Access Compliance Report

Public Rights-of-Way

Intersection ID: 54151	Main Street: SANDERS_FARM_LN	Cross Street: WALNUT_FOREST_DR	Location: SW
ADA ID: C10B28FE3B90	Ramp Type: Perp	Initial Pass/Fail: Fail	Overall Compliance: No
		Severity Score: 1.25

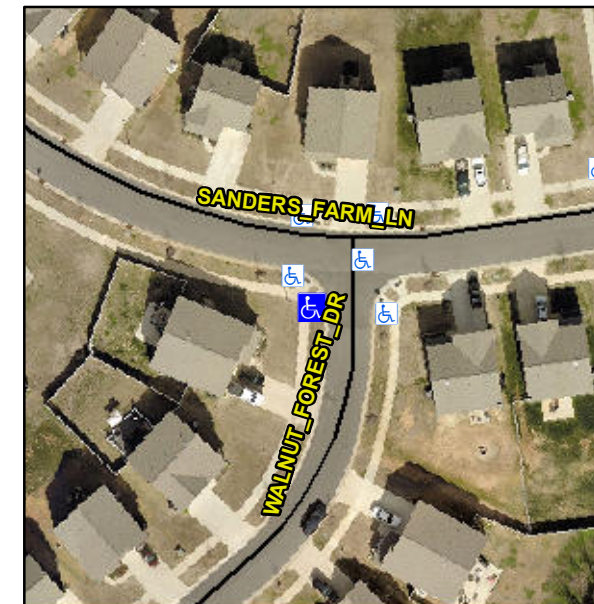
R304.5.3

Compliance	Description	Data	Compliance	Description	Data
N/A	Ramp Length (in)	94.5	Yes	Ramp Slope (%)	6.5
Yes	Ramp Width (in)	60.0	No	Ramp XSlope (%)	2.2
N/A	Flare Type LT	N/A	N/A	Flare Type RT	N/A
N/A	Flare Slope LT (%)	N/A	N/A	Flare Slope RT (%)	N/A
N/A	Flare Traversable LT?	N/A	N/A	Flare Traversable RT?	N/A
N/A	Landing Length (in)	N/A	N/A	DWS Provided?	N/A
N/A	Landing Width (in)	N/A	N/A	DWS Contrast?	N/A
N/A	Landing Slope (%)	N/A	N/A	DWS Length (in)	N/A
N/A	Landing X Slope (%)	N/A	N/A	DWS Full Width?	N/A
N/A	Landing Curb? (Y/N)	N/A	N/A	DWS Offset (in)	N/A
N/A	Shared Landing?	N/A			
N/A	Gutter Ponding?	N/A	N/A	Gutter Slope (%)	N/A
N/A	Gutter Lip Ht (in)	2.0	N/A	Gutter X Slope (%)	N/A
N/A	Painted X Walk1?	No	N/A	Painted X Walk2?	N/A
	X Walk 1 Direction	To E		X Walk 2 Direction	N/A
N/A	X Walk 1 Width (in)	N/A	N/A	X Walk 2 Width (in)	N/A
	X Walk 1 Slope (%)	0.2		X Walk 2 Slope (%)	N/A
	X Walk 1 X Slope (%)	2.1		X Walk 2 X Slope (%)	N/A

Remove & Replace Entire Ramp.
